Extension of the “Warning Display Function”

Check Take (Check the “take” just recorded)

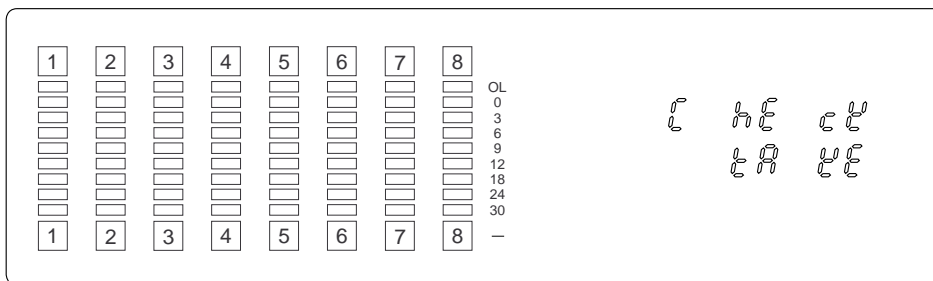
This display indicates that the D-90 Automatic Recovery System detected an error in the hard disk. When this error is shown, a problem has occurred in the take (such as drop out) and therefore this recorded section should be played back to check for any errors.

If no error is found, continue recording. If there is any problem, either rerecord or correct the error by editing.

Because the automatic recovery function is completed at the instant error is displayed, you can safely proceed to the next recording (refer to <Note> below.)

No Sound Recording (This recording is invalid)

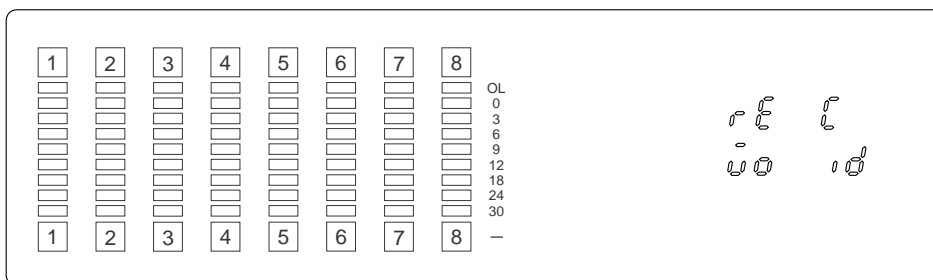
This display indicates that the D-90 Automatic Recovery System has canceled recording.

The take just recorded does not exist.

Because the automatic recovery function is completed at the instant error is displayed, you can safely proceed to the next recording (Refer to <Note> below).

As this warning functions only when in the “un do ALL” mode (or when “Can’t UNDO” of AUTO PUNCH IN/OUT is not displayed) of “19. Setting the Undo function area” in the D-90 SETUP mode, especially when making a “no second chance” recording such as live performance, the recording should be made by pressing the SETUP mode “19. Setting the Undo function area” to the “un do Edit” mode.
